Technical Service Bulletin

SUBJECT:			No: TSB-19-23-002
ADDITIONAL SERVICE PARTS FOR TRANSAXLE REMOVAL & INSTALLATION - SERVICE MANUAL REVISION			DATE: March 2019
			MODEL: 2013-15 Outlander Sport/RVR
CIRCULATE TO:	<input type="checkbox"/> GENERAL MANAGER	<input checked="" type="checkbox"/> PARTS MANAGER	<input checked="" type="checkbox"/> TECHNICIAN
<input checked="" type="checkbox"/> SERVICE ADVISOR	<input checked="" type="checkbox"/> SERVICE MANAGER	<input checked="" type="checkbox"/> WARRANTY PROCESSOR	<input type="checkbox"/> SALES MANAGER

PURPOSE

This TSB updates the Automatic Transmission section of the affected Service Manuals, to include additional service parts for the transaxle removal and installation procedure. These parts were made available in May, 2015.

TRANSAXLE CONTROL

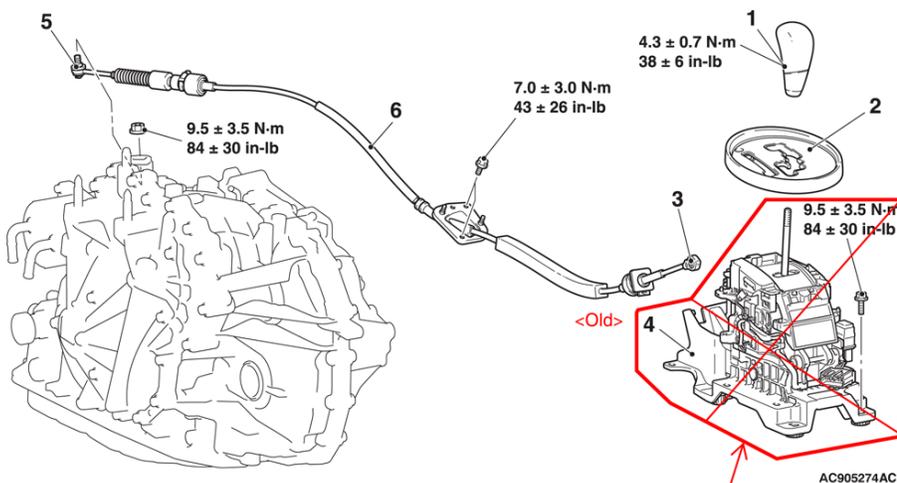
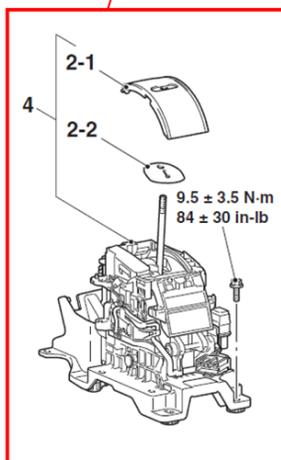
Please make the indicated changes to the 2013 Outlander Sport/RVR Service Manual, Group 23-Automatic Transmission -> 23A-CVT -> Transaxle Control -> Removal & Installation.

<New>

<Added>

- 2-1. Lever cover
 2-2. Indicator slider

TRANSAXLE CONTROL

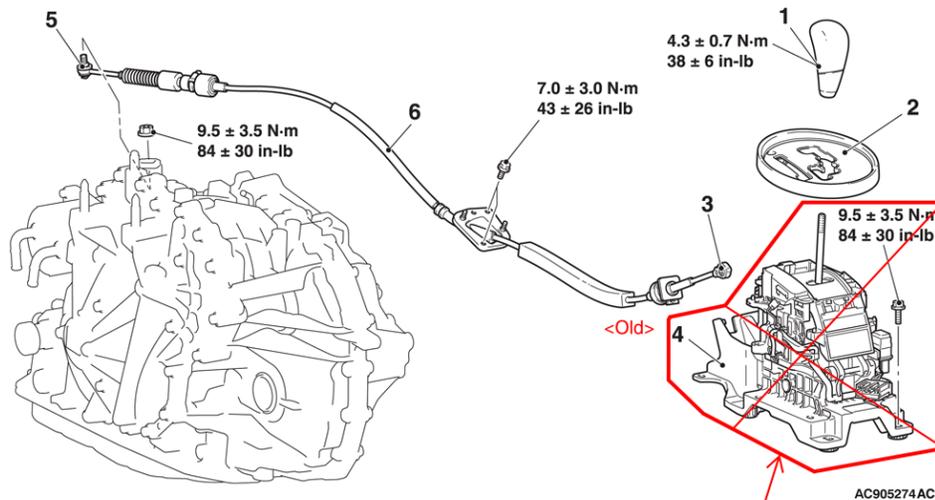
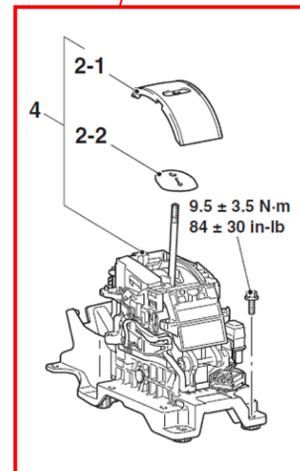
Please make the indicated changes to the following Service Manuals:

- 2014 Outlander Sport/RVR Service Manual, Group 23-Automatic Transmission -> 23A-CVT -> Transaxle Control -> Removal & Installation
- 2015 Outlander Sport/RVR Service Manual, Group 23-Automatic Transmission -> 23A-CVT <F1CJC/W1CJC> -> Transaxle Control -> Removal & Installation
- 2015 Outlander Sport/RVR Service Manual, Group 23-Automatic Transmission -> 23C-CVT <F1CJA/W1CJA> -> Transaxle Control -> Removal & Installation

<New>

<Added>

- 2-1. Lever cover
- 2-2. Indicator slider
